# Access Compliance Report

## Public Rights-of-Way

### (Curb Ramps)

Intersection ID: N/A	Main Street: LANGWELL_LN	Cross Street: HAMILTON_BRIDGE_RD	Location: SW
ADA ID: F2F39EC3D9EF	Ramp Type: Perp	Initial Pass/Fail: Fail	Overall Compliance: No
Codes/Mitigation Info/Possible Solution		Field Measurements/Component Compliance

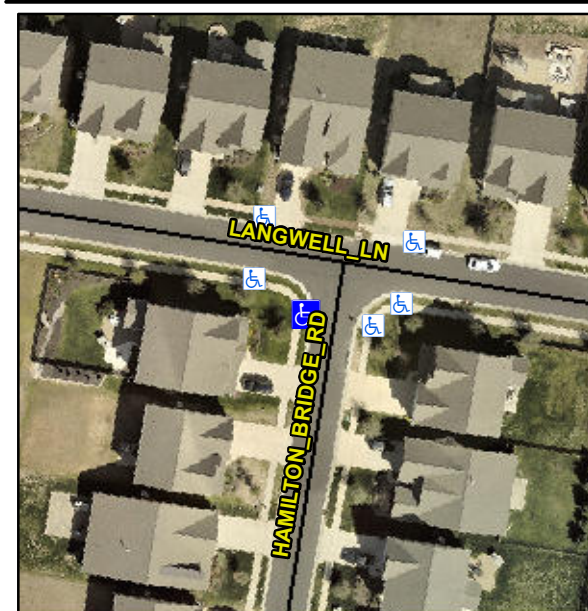
**R304.5.1**

Compliance	Description	Data	Compliance	Description	Data
N/A	Ramp Length (in)	48.0	Yes	Ramp Slope (%)	6.3
No	Ramp Width (in)	47.5	Yes	Ramp XSlope (%)	3.5
N/A	Flare Type LT	N/A	N/A	Flare Type RT	N/A
N/A	Flare Slope LT (%)	N/A	N/A	Flare Slope RT (%)	N/A
N/A	Flare Traversable LT?	N/A	N/A	Flare Traversable RT?	N/A
N/A	Landing Length (in)	N/A	N/A	DWS Provided?	N/A
N/A	Landing Width (in)	N/A	N/A	DWS Contrast?	N/A
N/A	Landing Slope (%)	N/A	N/A	DWS Length (in)	N/A
N/A	Landing X Slope (%)	N/A	N/A	DWS Full Width?	N/A
N/A	Landing Curb? (Y/N)	N/A	N/A	DWS Offset (in)	N/A
N/A	Shared Landing?	N/A			
N/A	Gutter Ponding?	N/A	N/A	Gutter Slope (%)	N/A
N/A	Gutter Lip Ht (in)	N/A	N/A	Gutter X Slope (%)	N/A
N/A	Painted X Walk1?	No	N/A	Painted X Walk2?	N/A
	X Walk 1 Direction	To SE		X Walk 2 Direction	N/A
N/A	X Walk 1 Width (in)	N/A	N/A	X Walk 2 Width (in)	N/A
	X Walk 1 Slope (%)	1.3		X Walk 2 Slope (%)	N/A
	X Walk 1 X Slope (%)	4.1		X Walk 2 X Slope (%)	N/A

**Remove & Replace Entire Ramp.**
